2024.1.31

TITLE: Sheet_1		REV: 1.0
	Company: Your Company	Sheet: 1/1
	Date: 2023-11-09	Drawn By: Denjhang

TITLE: Sheet_1		REV: 1.0
		Sheet: 1/1
Company: Your Company		Date: 2023-11-09 Drawn By: Denjhang

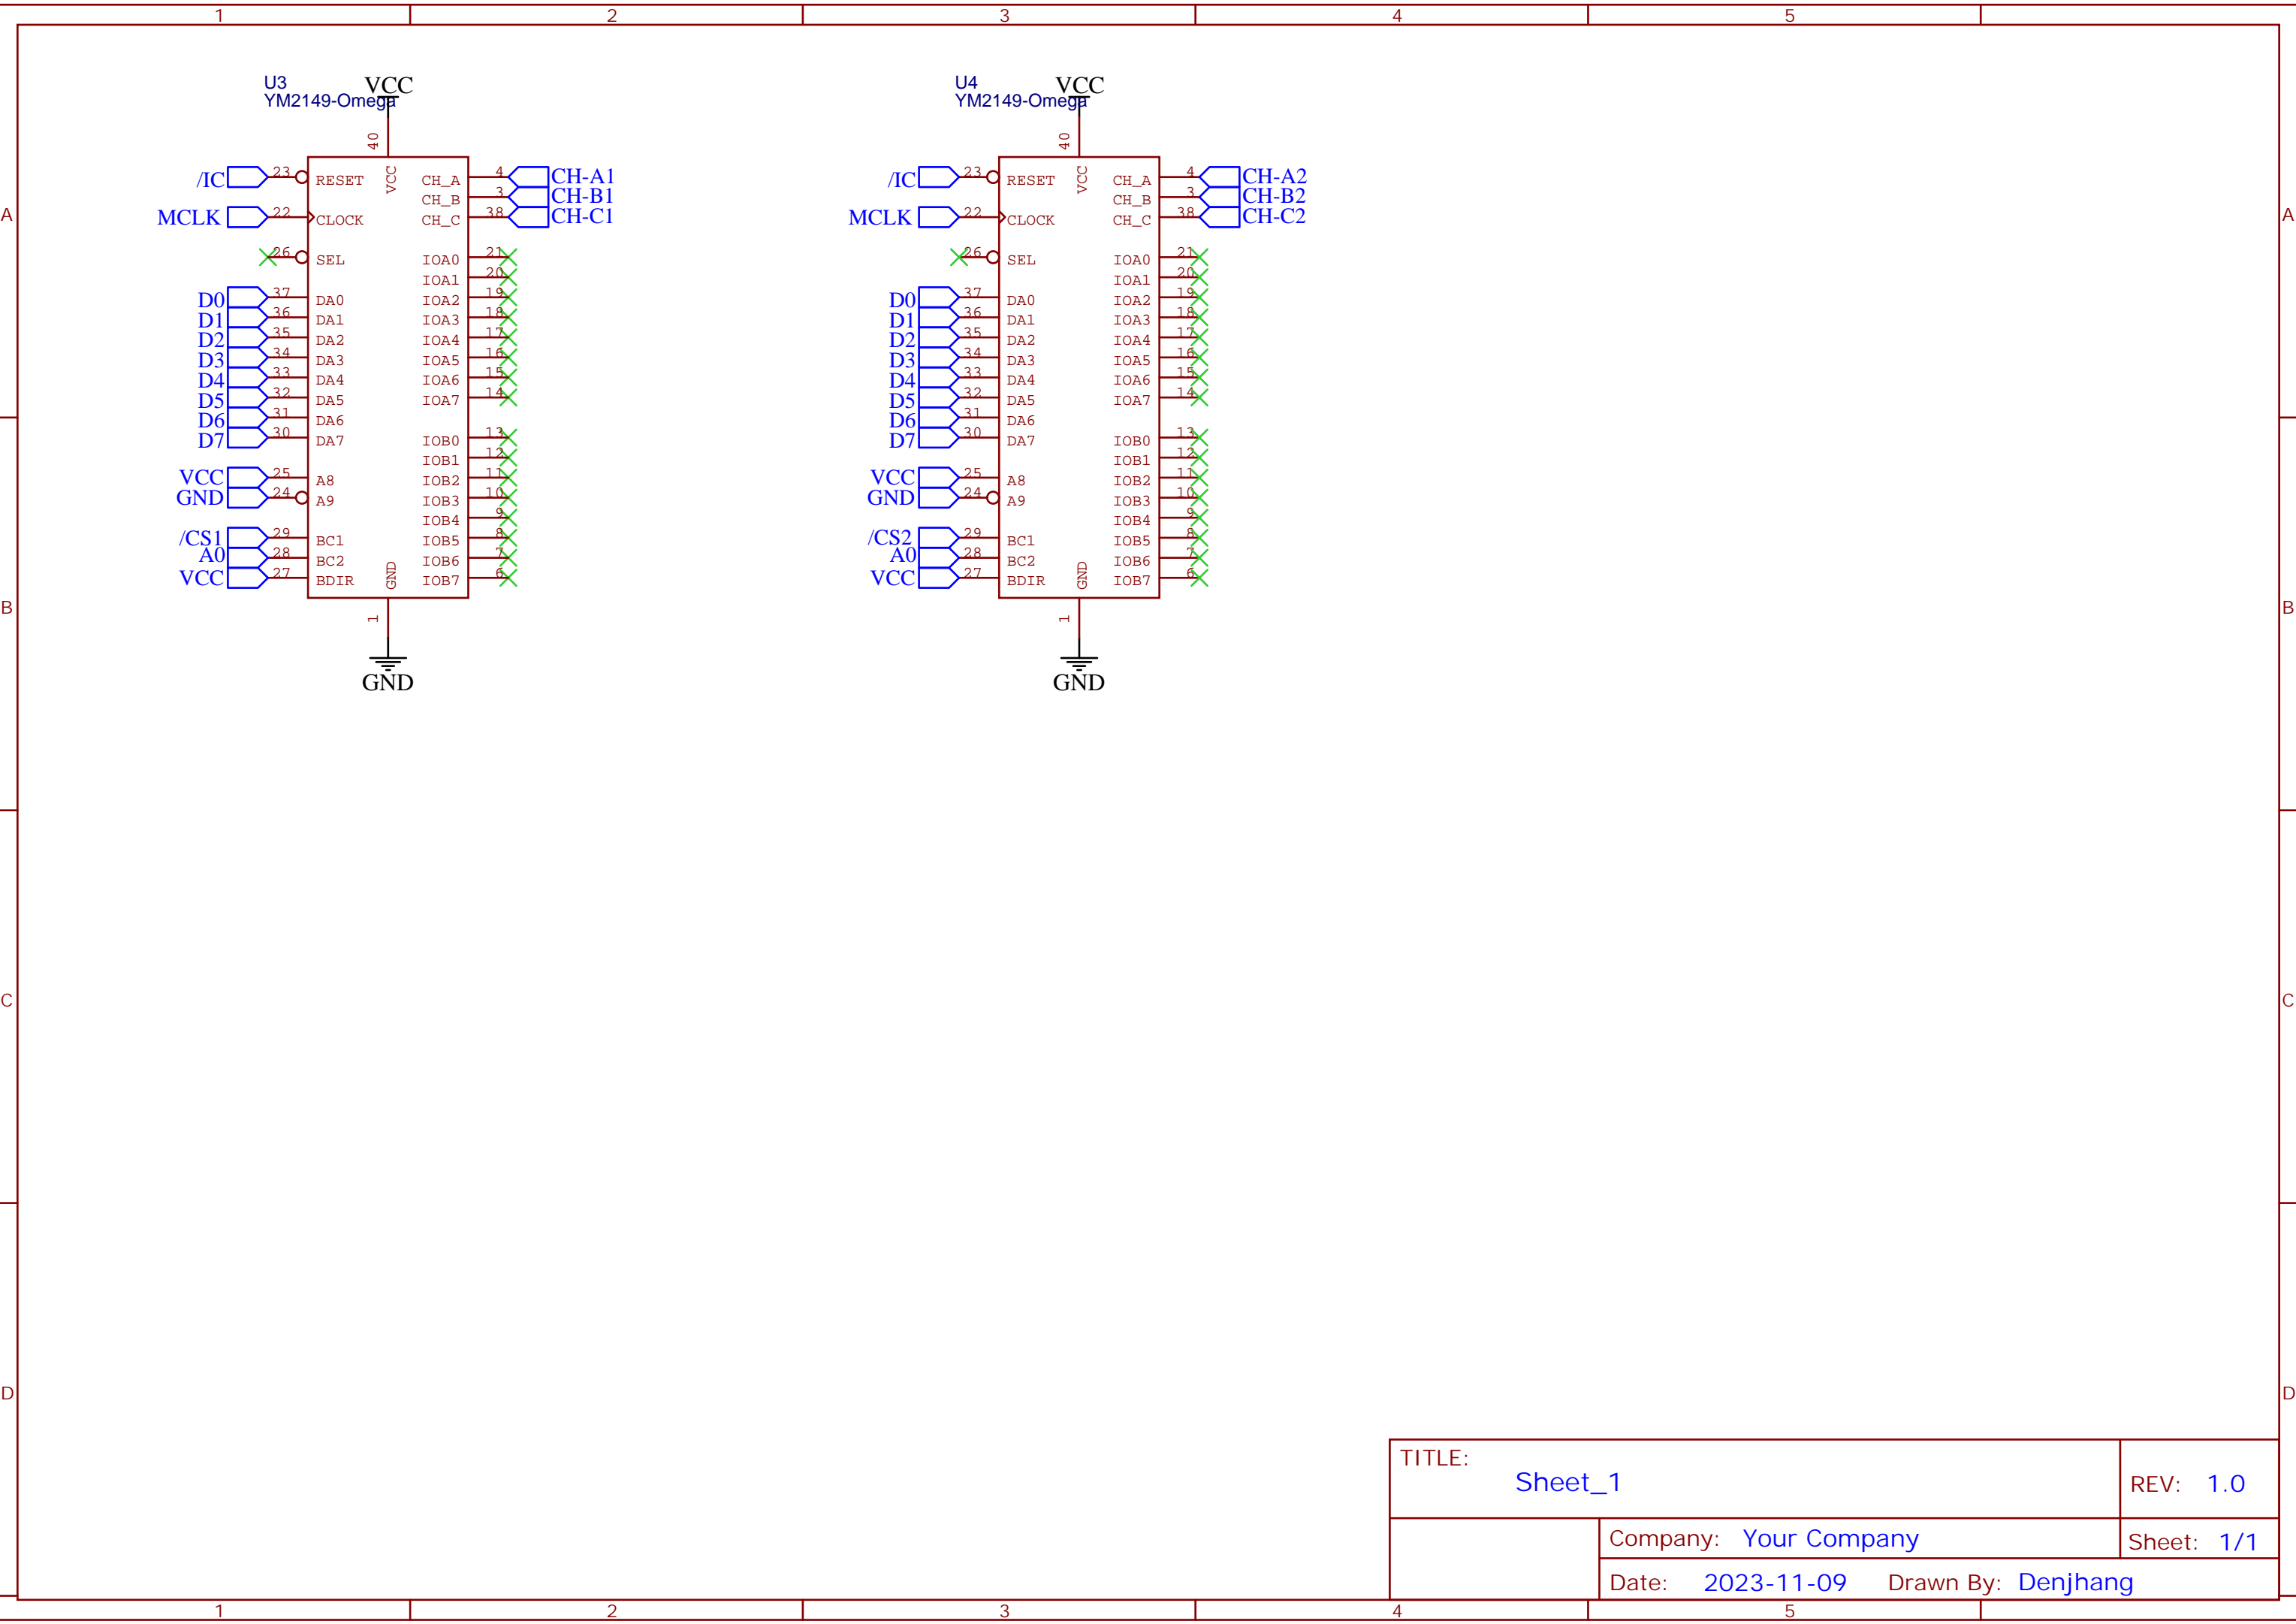
1.修复A.VCC

2.删除多余的二极管

低级错误，此处应该引入A.VCC

TITLE: Sheet_1		REV: 1.0
	Company: Your Company	Sheet: 1/1
	Date: 2023-11-20 Drawn By: Denjhang

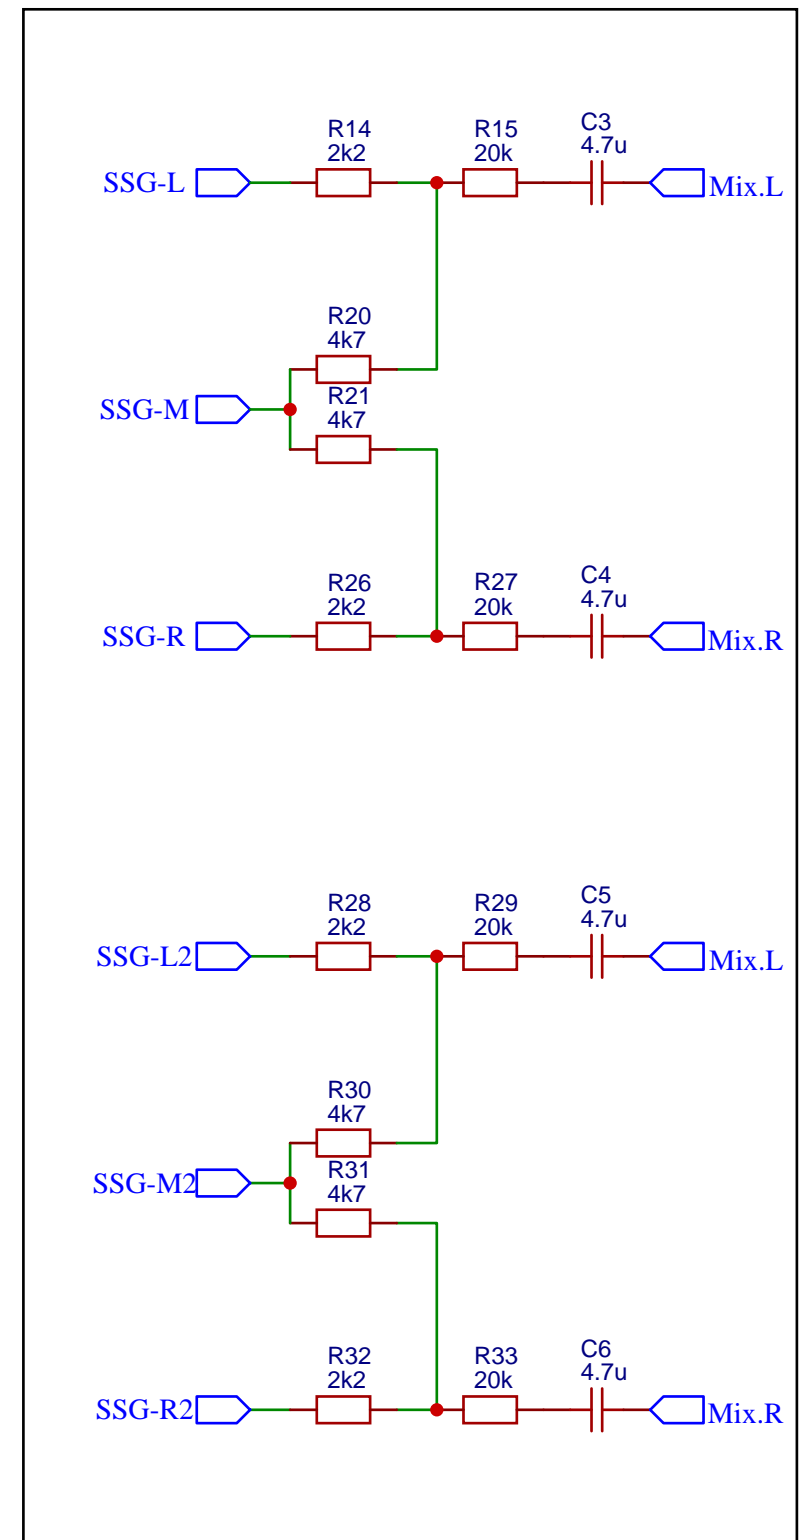
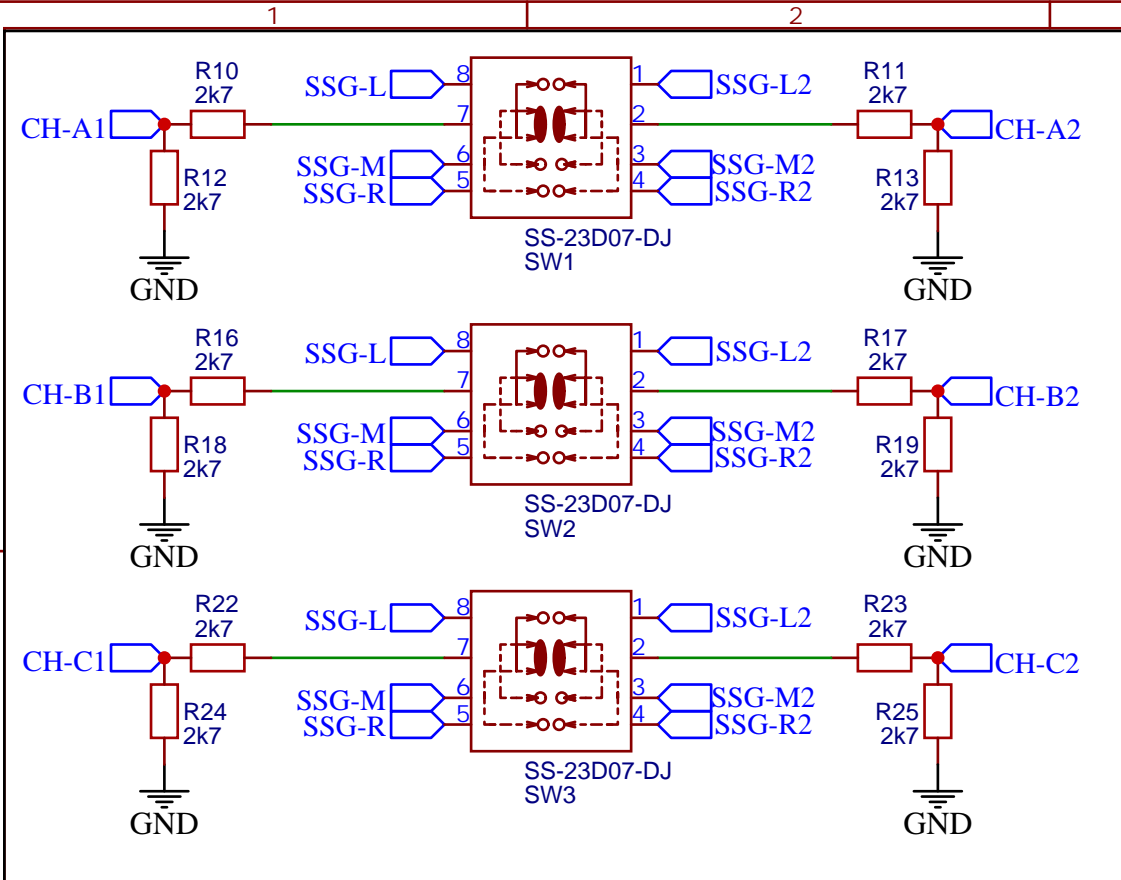
SSG在过下拉电阻之前，禁止接电容
此处参考RC2014-YM2149的黄金比例立体声混音
